## Response to Reviewer #1 – Patrick Volker

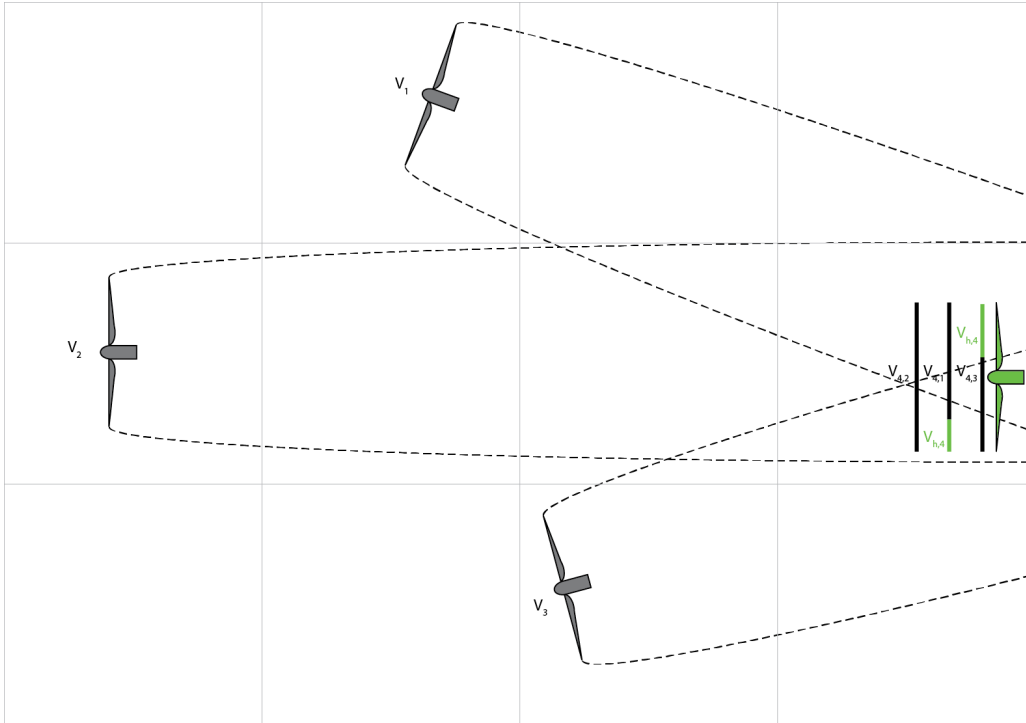
(III) Regarding the M4 method. One would assume that proceeding downstream the wind speed would decrease and ideally reach at a certain point an equilibrium. When I tried just an example with 3 turbines having wind speeds of 7, 6 and 5m/s. Then, the wind speed of the 4th turbine would be  $\sqrt{110/3} = 6.1\text{m/s}$ , which is above the 5m/s of the 3th turbine. However, it is also not clear if the M4 method would not just start at the first turbine and proceed one by one downstream. If the first turbine would face say 8m/s, then the wind speed at the second turbine would be  $U_2 = \sqrt{64/1}=8\text{ m/s}$  and at the thirist turbine it would be  $U_3 = \sqrt{(64+64)/2} = 8\text{ m/s}$ , is this right?

*To understand this, let’s look at the figure below, in which each turbine is in its own grid cell and the wind directions are slightly different in each grid cell, as is the case in real simulations (also the wind speeds are different, of course).*

*Turbine 4 is affected by 3 wakes, each of which causes its own wind speed (e.g.,  $V_{4,1}$  is caused by turbine 1 and is a partial wake case, with some of the rotor affected by the wake and the rest unaffected, thus experiencing  $V_{h,4}$ ). The example that you suggested is such that  $V_{4,2} = 7$  m/s,  $V_{4,1} = 6$  m/s, and  $V_{4,3} = 5$  m/s. These are the resulting wind speeds at turbine 4, they are not the wind speeds at the upstream turbines. [Maybe this was a reason of confusion?] The resulting wind speed at turbine 4 will be 6.1 m/s, as you calculated, as a result of the mixing of the three individual wakes. Why should the resulting wind speed be lower than 5 m/s? If that was the case, neither mass nor momentum nor energy would be conserved and the equilibrium that the reviewer correctly referred to would never occur (it would monotonically decrease).*

*If, as the reviewer implicitly assumed, the turbines are aligned, then this is less intuitive and may even appear to be incorrect. We are used to seeing the squared deficits from the Jensen's top hat shape overlapping and reducing the wind speed more and more with more overlapping wakes via the M2 method. This is actually not happening in the real world. We know that the wind power and wind speed plateau very quickly at the second or third turbine in a row, due to partial wake recovery and entrainment. If you look at the figures in our manuscript for directions  $222^\circ$  or  $180^\circ$  at Lillgrund, or  $339^\circ$  and  $183^\circ$  at Anholt, you will see observational data that indicate that the third turbine generates more power than the second. With method M2 this cannot be reproduced, but with M4 it is.*
